Demolition of an existing building and construction of a multi-storey mixed-use building (ground plus 6 levels above ground), comprising retail and residential uses and associated basement car park.

69-71 Melbourne Street, North Adelaide

020/A097/18

ASSESSMENT REPORT

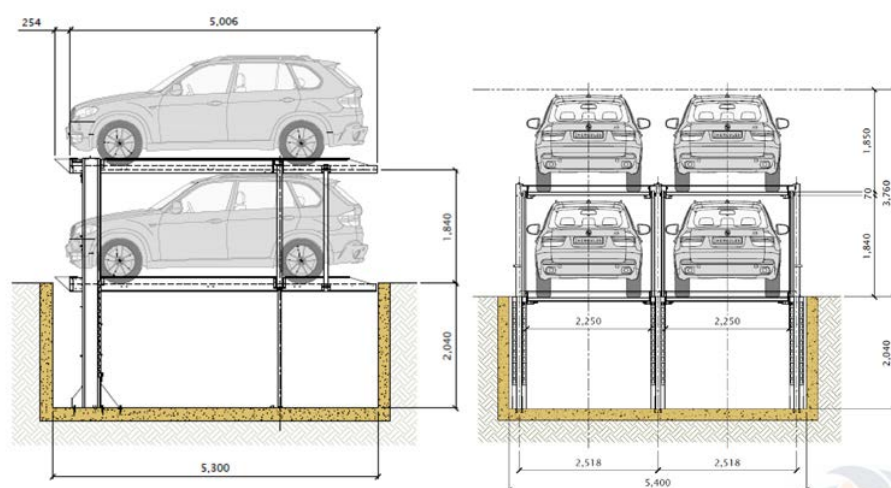
This leaves the storage heavily reliant on the over bonnet storage. There is no detail on the plans, nor the car stacker pamphlet that shows how over bonnet storage would be accommodated.

Regardless of the above, while it is considered that there is a deficiency in storage, given the extra generosity provided by the laundries and walk-in robes, and that the apartments meet the minimum size requirements sought by the Development Plan, this is not considered to be detrimental to the overall scheme, provided that detail outlining how the over bonnet storage can be achieved is provided. Without further detail, it is considered that the proposal does not meet the storage provision requirements of the Development Plan.

2 NORTH-SOUTH PRIVACY SECTION 1:100

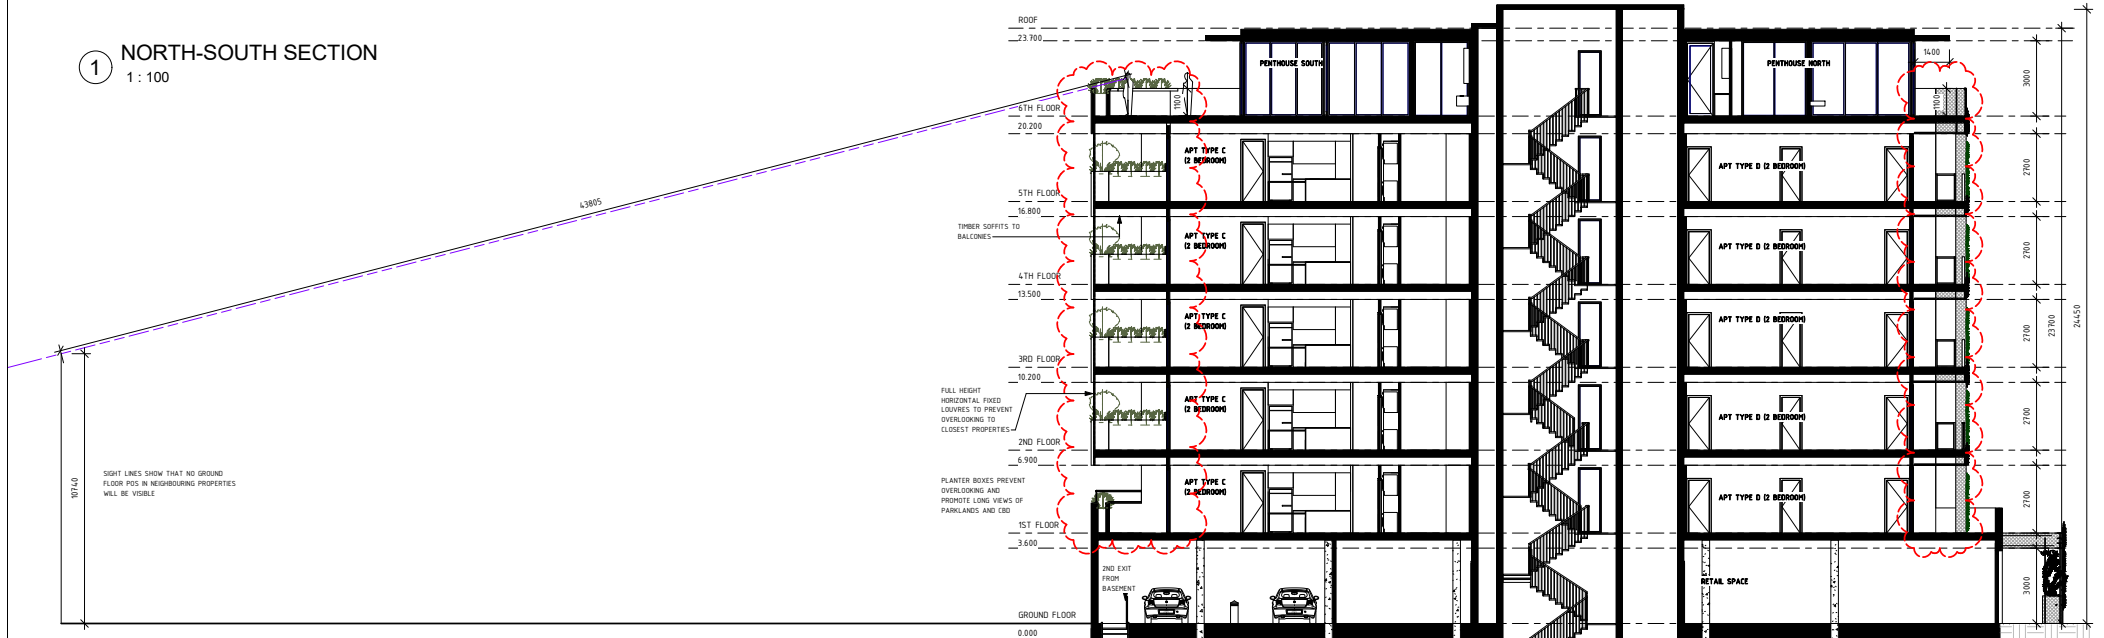
Second, it is clear from the North – South Privacy Section on Drawing PL.08 that the sixth floor level will not be visible from the private open spaces on the north-western side of Units 11 or 12, or from the ground or first floor levels of Units 11 or 12.

Second, it is clear from the North – South Privacy Section on Drawing PL.08 that neither the habitable room windows nor the private open spaces on the north-western side of Units 11 and 12 will be visible from any of the apartments at the south-eastern end of the proposed building courtesy of the screening measures which have been adopted.

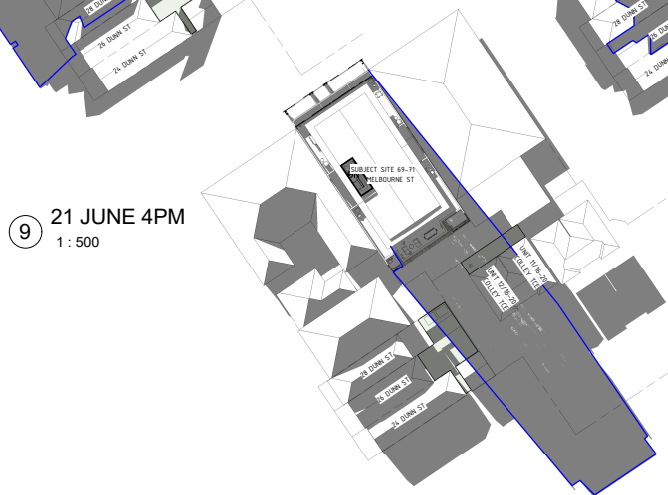
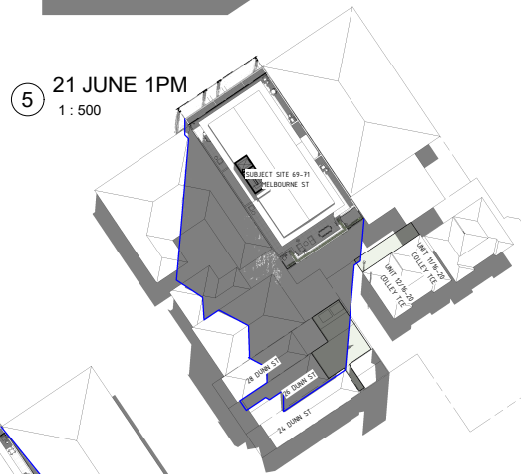
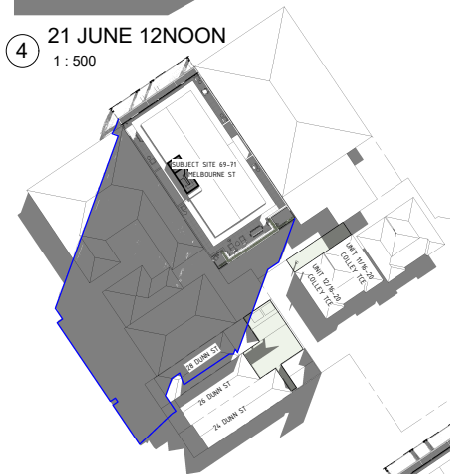
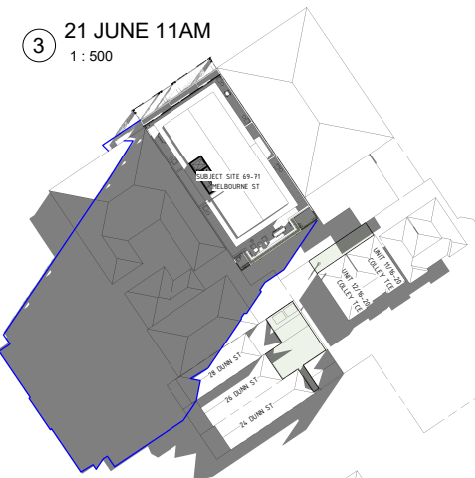
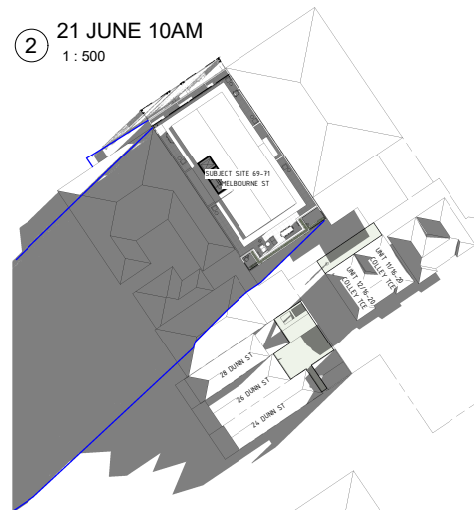
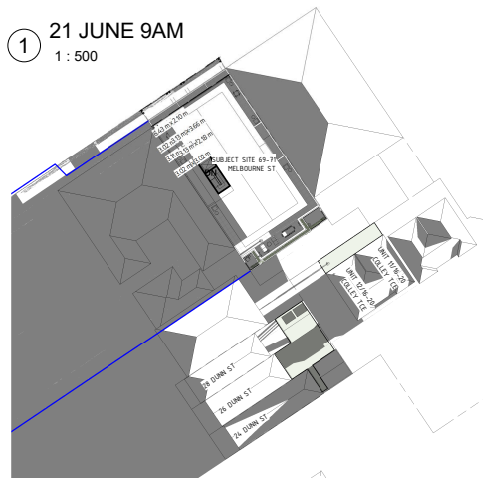
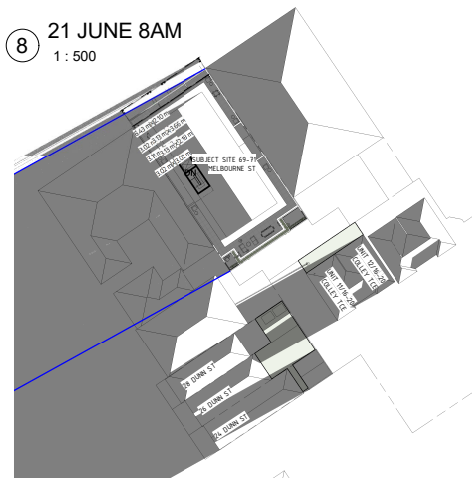
These representors need not be concerned, as it is clear from the diagrams on Drawing PL.10 that the proposed building will not cast a single shadow over the habitable room windows or private open spaces of Units 1, 11 or 12 until 3:00 pm, 4:00 pm and 1:00 pm respectively.

Notwithstanding this, it is also important for these representors to note that the diagrams on Drawing PL.10 depict the worst-case scenario in that the winter solstice marks the shortest day of the year and is when the sun is at its lowest point in the sky. They are also based on the assumption that there will be no cloud cover whatsoever during the middle of winter.
